EKCO SW86 mods

Richard Brayne and James Davidson

EKO SW86 - modified circuit

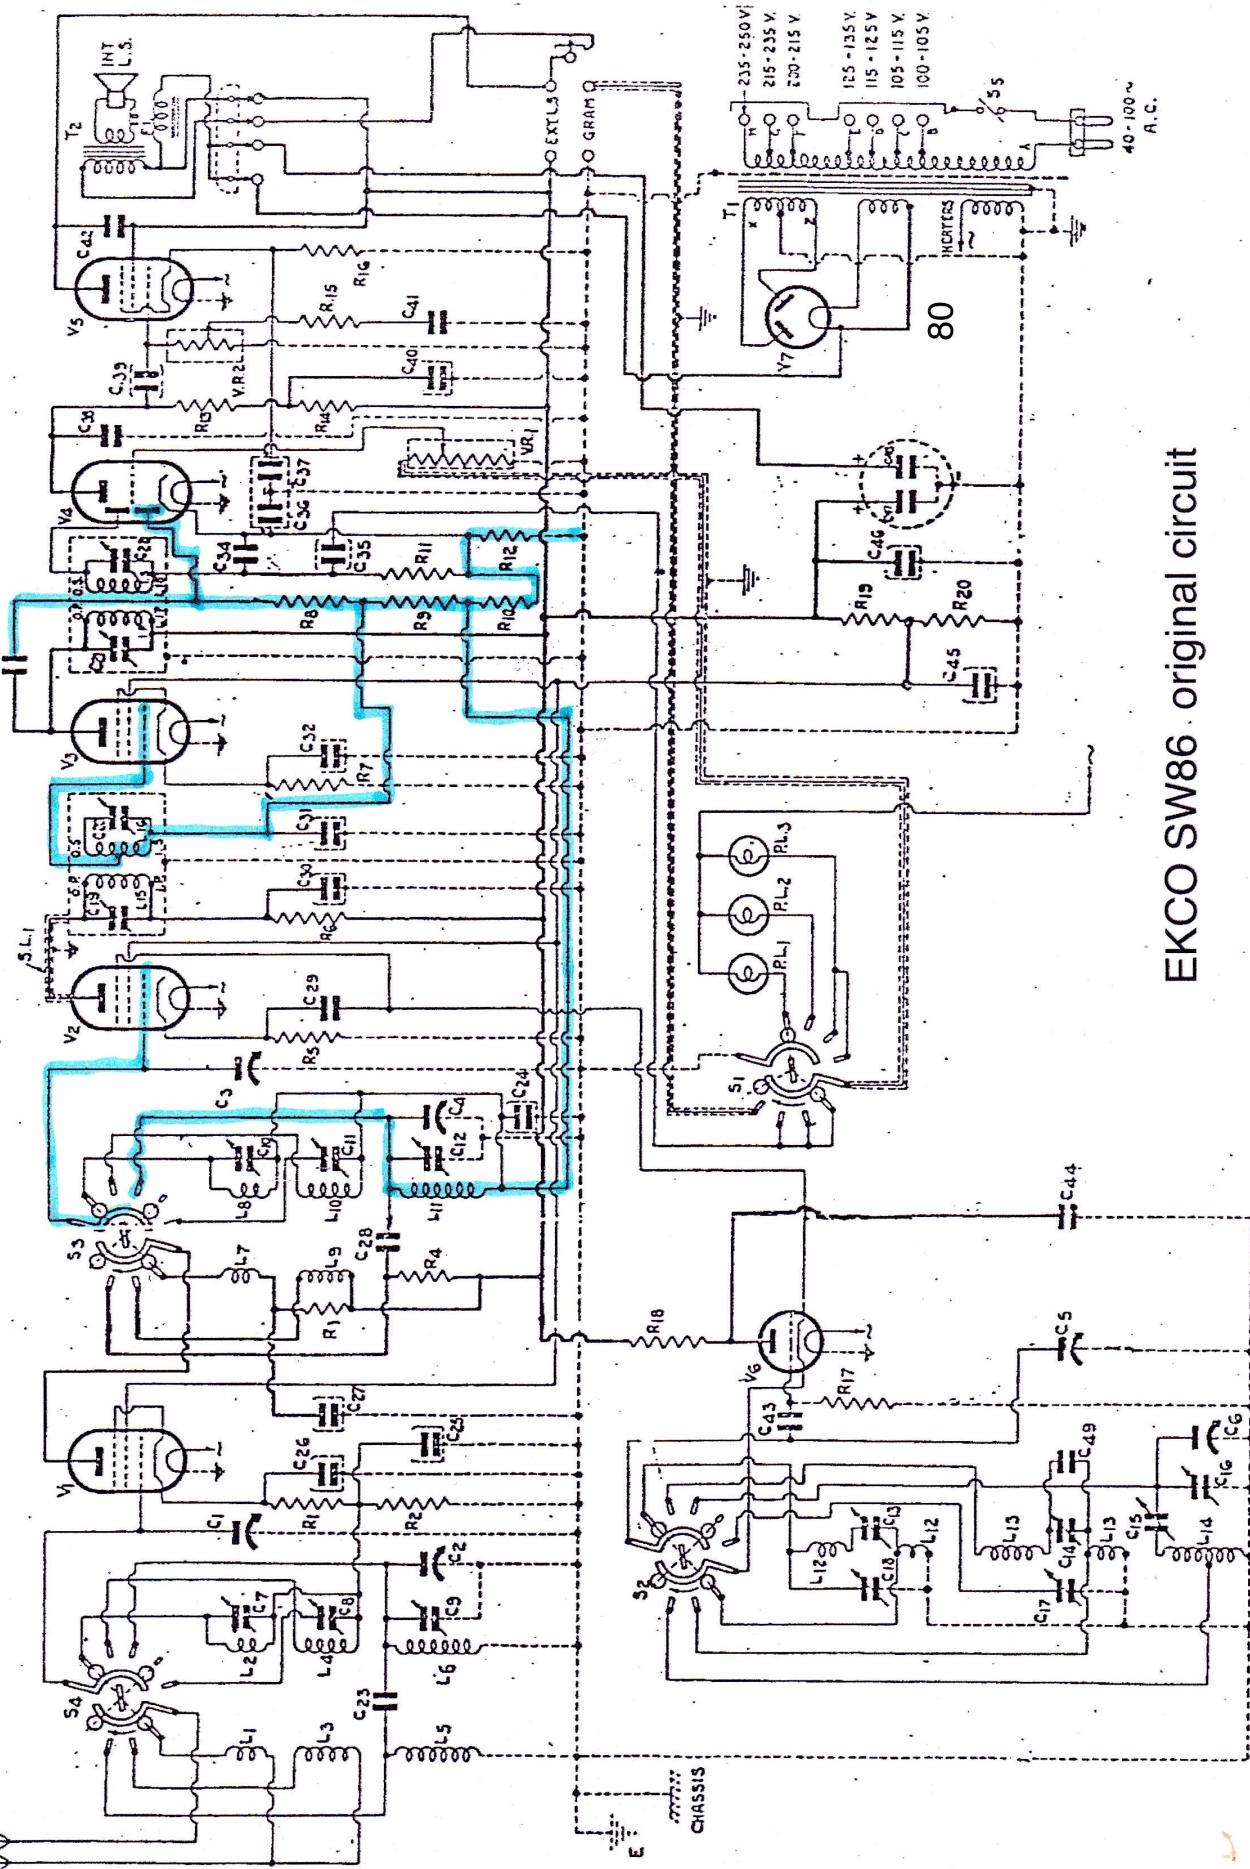
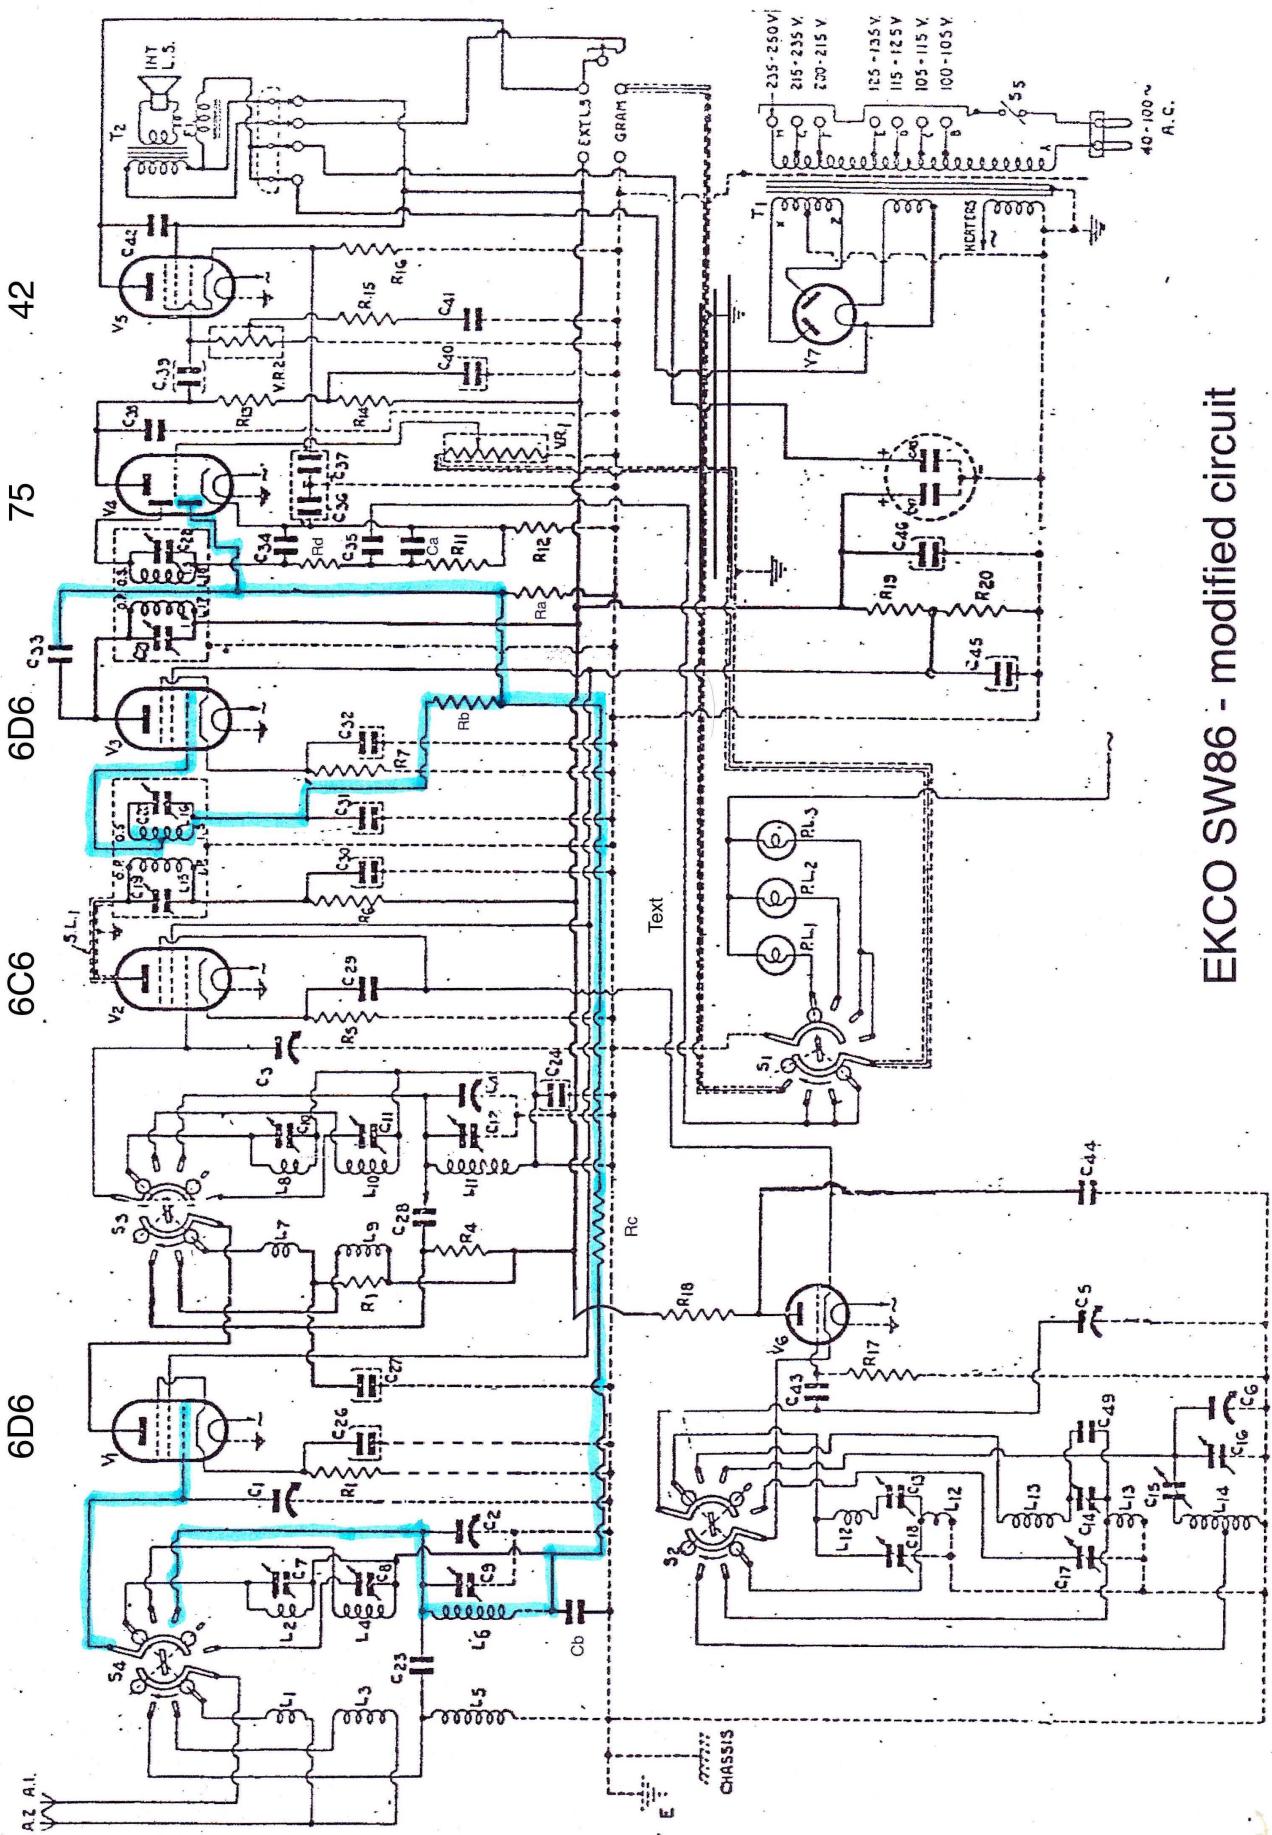
1. The RF valve V1 (6D6) has fixed bias, with no AGC voltage applied. With an uncontrolled RF stage overload readily occurs, and the designers evidently found it necessary to bias back the 6D6 RF valve with an additional 1500Ω cathode resistor (R2). The cathode bias resistor is switched between 325Ω (bias -3V) for the SW bands, and 1825Ω (bias approx. -8V) for the BC band. The overall result is poor BC band sensitivity.

2. The mixer valve V2 (6C6) is a sharp cutoff pentode, an unsuitable type of valve for AGC bias control, which requires a variable-mu valve. The 6C6 is operated with a grid bias of around -5V (no signal), close to its cutoff grid voltage (-7V). The 6C6 receives 58% of the generated AGC voltage and as a result strong signals can cause complete signal cutoff (this has been observed in at least 1 set).

3. There is no AGC delay voltage, as the AGC diode load is returned to the 75 cathode, not to earth.
4. The signal diode RF filter comprises a single 500pF capacitor (C34) instead of the usual RF filter network. This may not be optimal for reproduction of high audio frequencies.

1. Remove AGC from the 6C6 by disconnecting the bottom end of L11 from R9/R10, and connecting it to earth. (C24 is now redundant but can be left in situ, thankfully, as it is cleverly buried under the wave band switch).
2. Replace R8, R9 and R10 in the AGC circuit with a single $1M\Omega$ resistor (Ra) as the new AGC diode load, which is returned to earth, (thereby applying a delay voltage to the AGC line). Connect a $2 M\Omega$ resistor (Rb) between C31 and Ra.

3. Add AGC bias to V1 as follows:
 - a) Disconnect the bottom of L2 (call this point X) from C25/R1/R2.
 - b) Disconnect the bottom of L6 from earth, and connect it to X.

- c) Connect a $0.05\mu\text{F}$ capacitor (Cb) between X and earth.
 - d) Connect a $2\text{M}\Omega$ resistor (Rc) between X and Ra.
4. Replace R1 and R2 with a single 470Ω resistor to decrease the excessive bias on V1 and improve sensitivity on the BC band. Discard C25 which is now redundant.

5. Replace C34 (500pF) with a 100pF capacitor, and add a 56K resistor (Rd) and a second 100pF capacitor (Ca) to form a proper RF filter in the signal diode circuit.

6. Replace R11 (signal diode load) with $250\text{K}\Omega$, and replace the volume control pot VR1 with a $1\text{M}\Omega$ pot. These measures are intended to prevent distortion at high modulation levels due to AC shunting of the audio signal (see MG Scroggie, Foundations of Wireless, 7th ed., p223).
